Oswald, Hank Wednesday, September 1, 2021 8:54 AM Brian Johnson; Randy Bachtel RE: OSDS Plan\_12010 Simpson Road

The following comments pertain to the review of the OSDS Plan for 12010 Simpson Road.

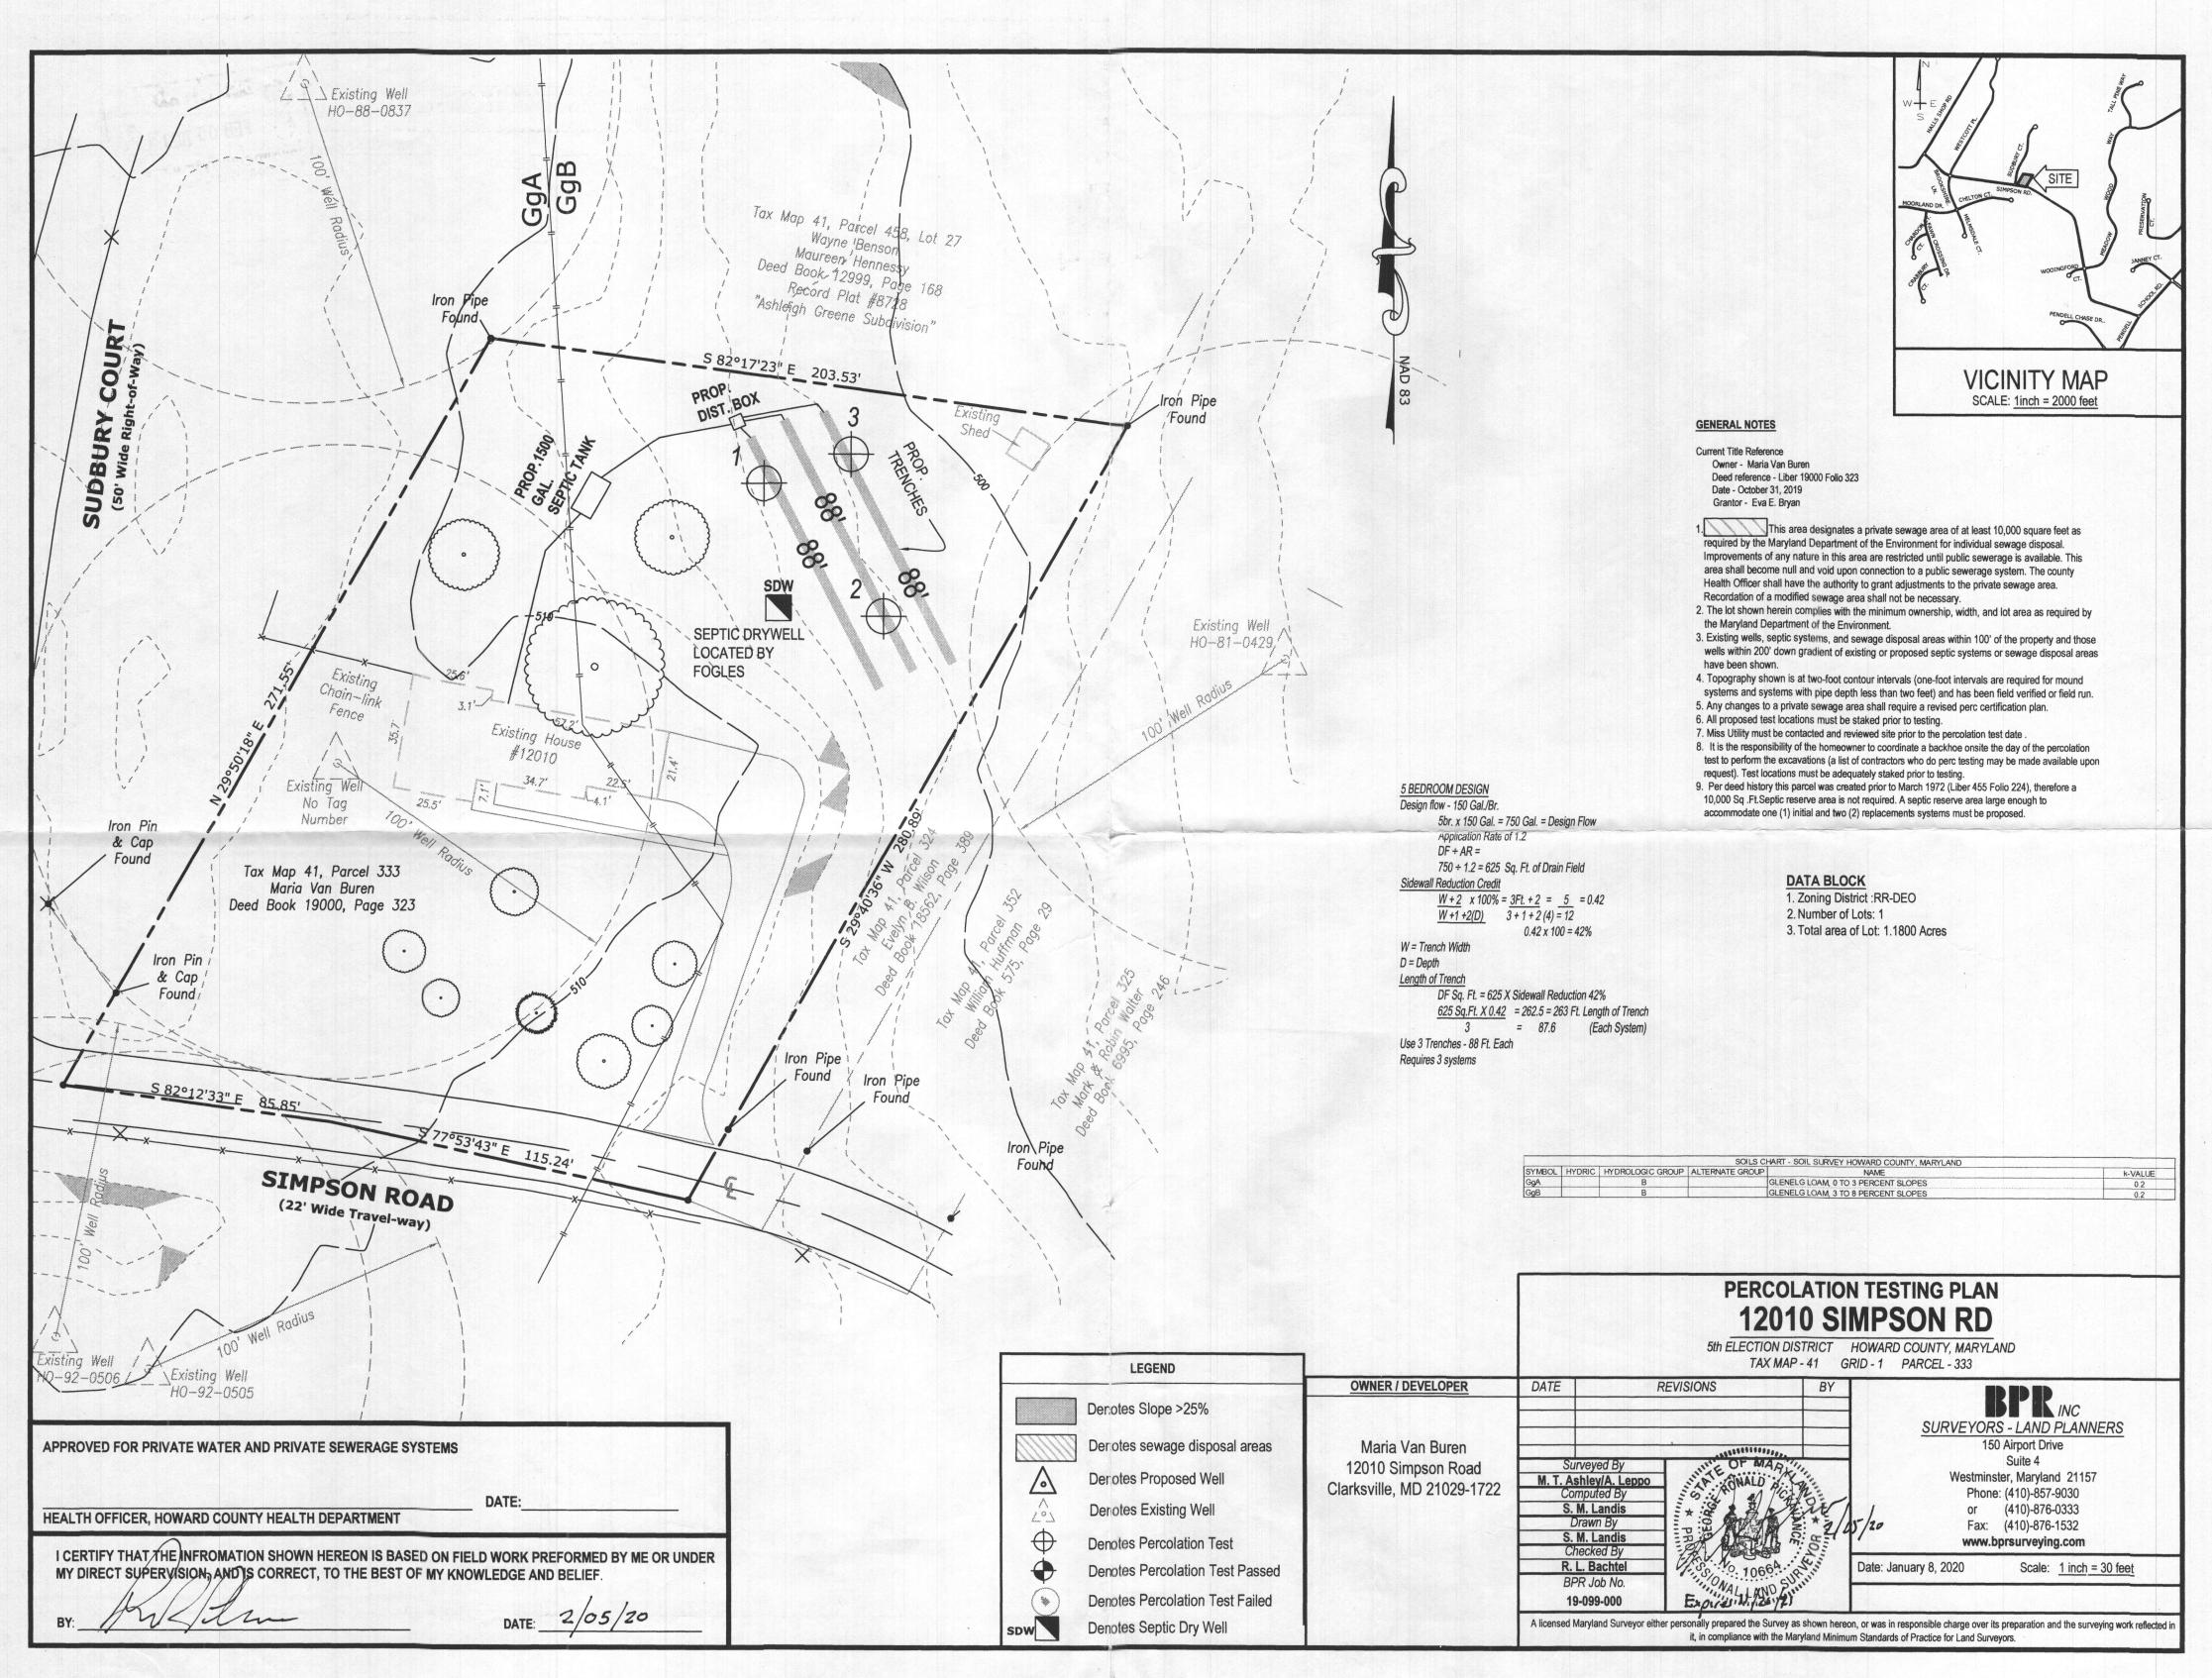
- Show approved SDA on OSDS Plan. The SDA has been slightly modified near tanks. (See attached plan). Any changes to the SDA shall require a revised perc cert plan. The approved SDA has been shown on the OSDS Plan.
- 2.) Show emergency storage calculation. "The pump chamber must have the capacity to accommodate a pump positioned on a six inch riser, one dose volume, and one day's design flow storage capacity above the high water alarm."

3.) Show pump tank 20 feet from house foundation. Pump tank is within 20 feet of the setback to the house. The homeowner may ask for a waiver to the setback if that portion of the house is on crawlspace. Simplified floor plans will be needed for the waiver.

- 4.) Raise trench inverts to 2 feet for better use and design of the trench. Not Applicable. Gravity Septic achieved.
- 5.) Change FM to 2 inch for lower friction loss/within the table limits. (See attached Table 4.4; 2.62) Not Applicable. Gravity Septic achieved.
- 6.) Minimum dose is  $1/6^{th}$  design flow. 7 x 150/room = 750/6 = 125 gallons.

- 7.) Show total dynamic head calculation.
- Not Applicable. Gravity Septic achieved.

Not Applicable. Gravity Septic achieved.

A Waiver has been included with this submission.

Not Applicable. Gravity Septic achieved.
